# Memorandum

**Re:** Re-submittal of Site Plan, 9610 and 9630 Universe Boulevard NW (PR-2020-004024/SI-2024-00648)

The following memo provides responses to staff comments for the Site Plan Administrative application heard on July 3, 2024. Staff comments are in italic followed by the Applicant responses.

**EL-1**  
 FLOOR PLAN

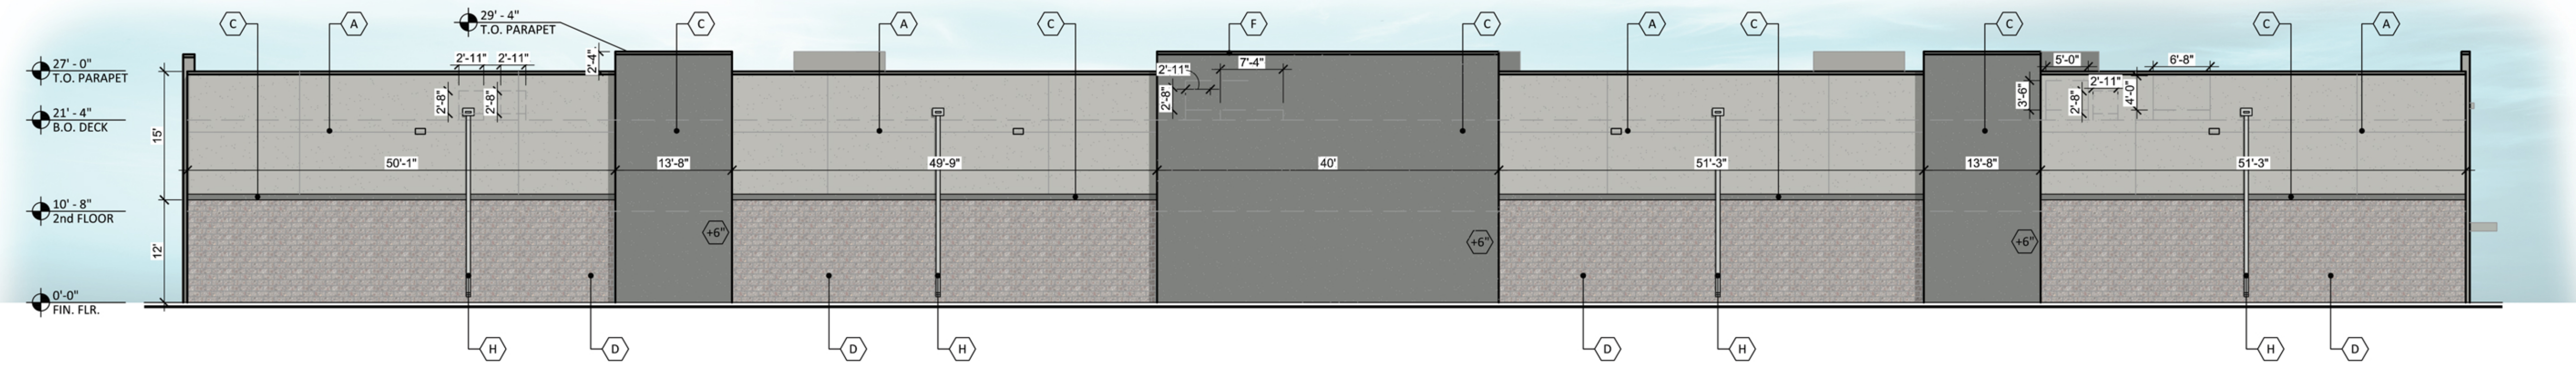
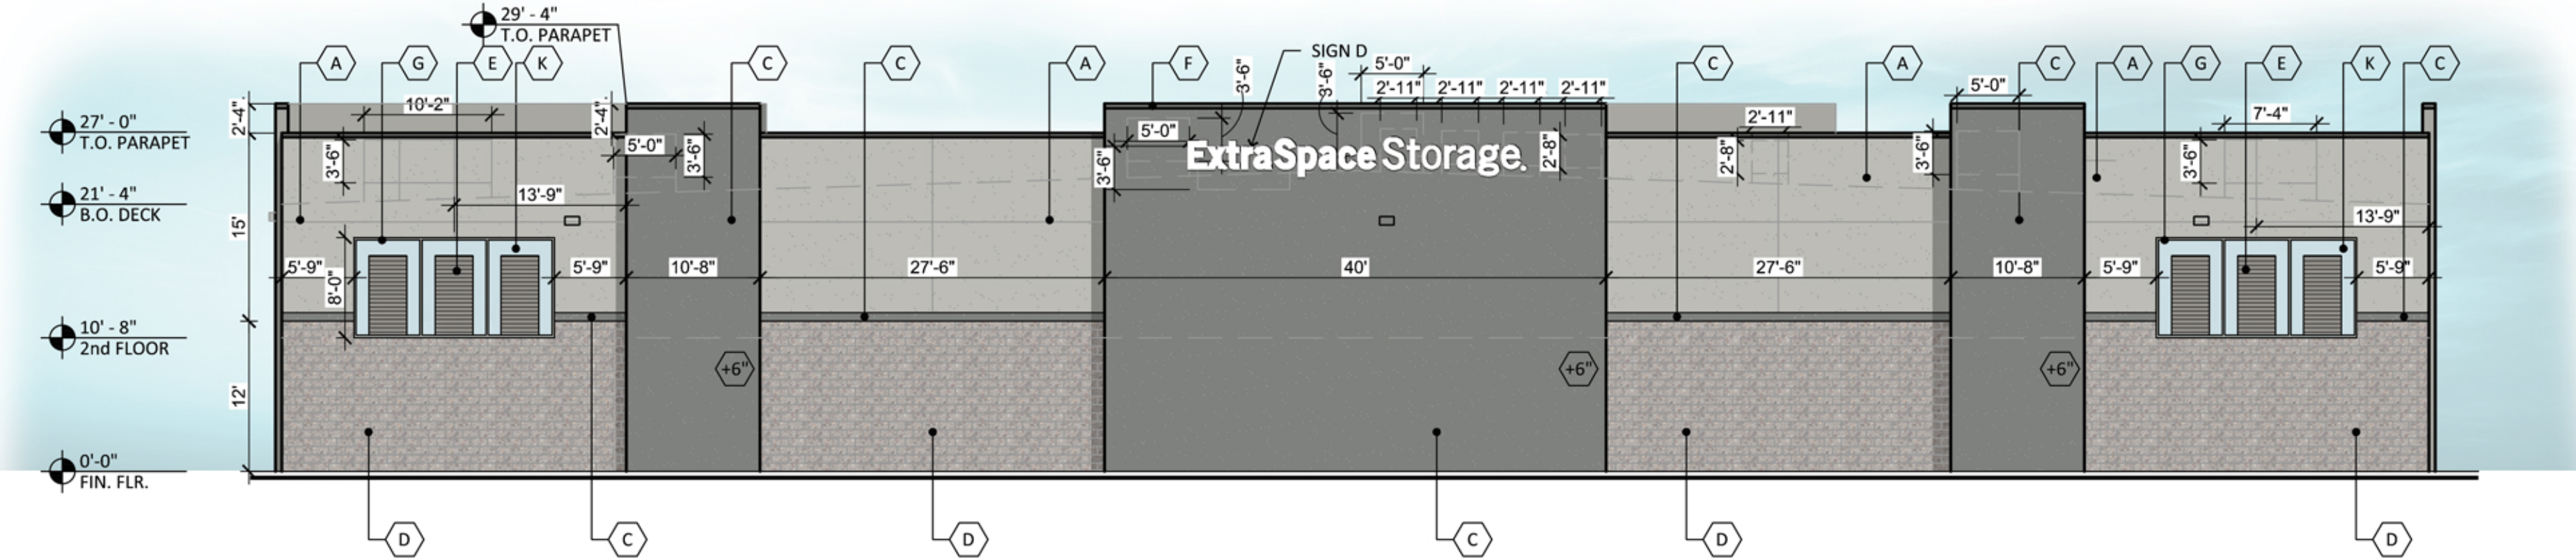
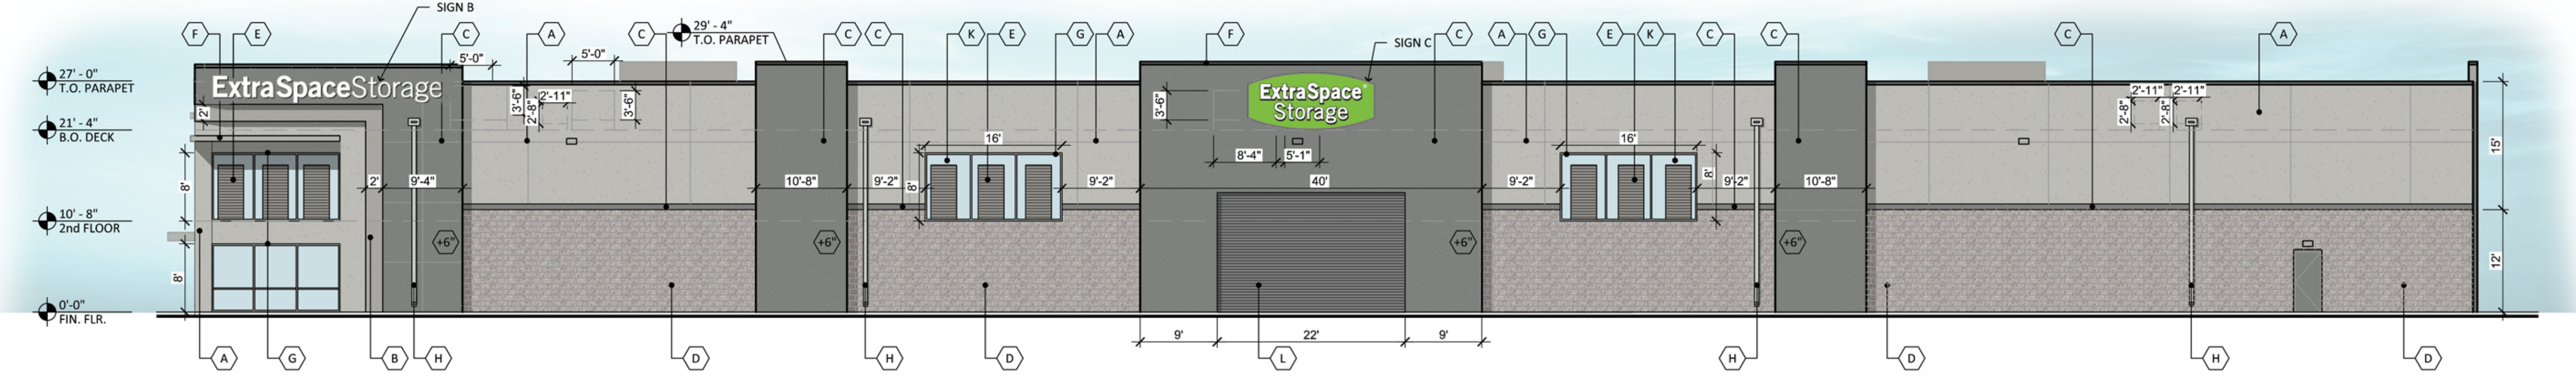
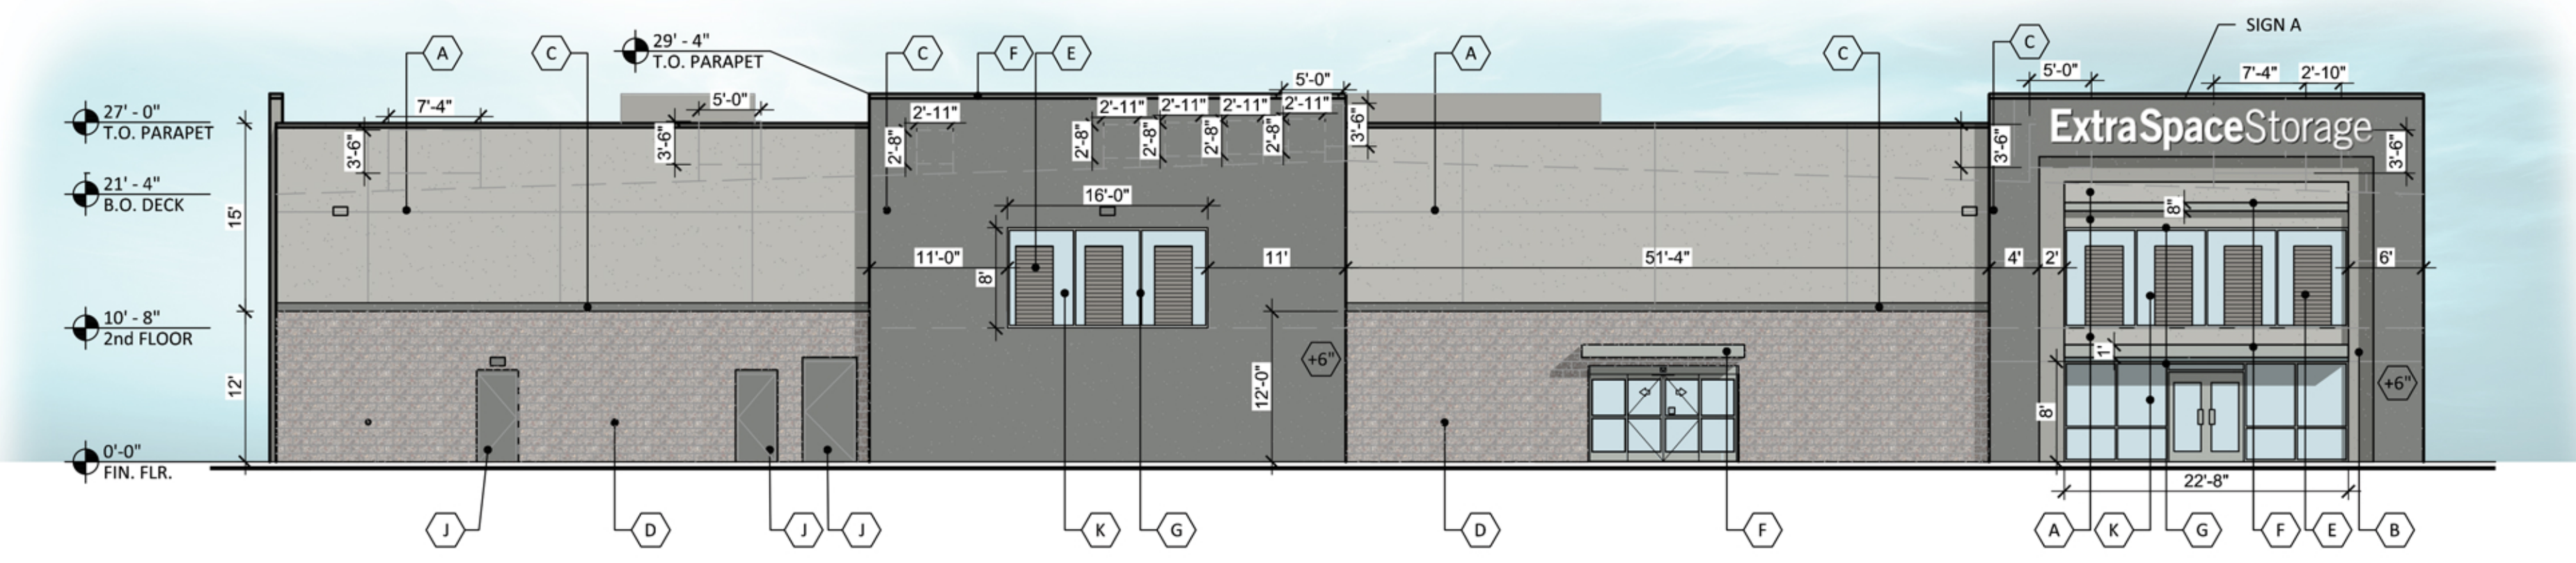
*Page 6: (2)(a)(2) – The façade incorporates two features: windows on upper floors and - ?? Primary pedestrian entrance.*

*Page 6: Please add the following note: "Rolled doors visible in the faux windows must match the color of the building façade, i.e., gray, and is not highly visible when lit."*

**Applicant Response:** The site does not have a street-facing façade, and therefore is not required to meet the standards in *IDO Section 5-11(E)(2)*. The south and western façade may be visible from Universe Boulevard and Paseo del Norte, but the building is located behind existing development which obscures the building. The proposed façade includes articulation, color variation, and windows on the upper floor contributing to an attractive building design.

**Applicant Response:** The Applicant proposes that the note be slightly modified to allow adjustments to the color provided they are muted and are within the color palette specified in the VPO-2. The Applicant proposes the following note:

"Rolled doors visible in the faux windows shall be muted colors as shown on the building elevations."
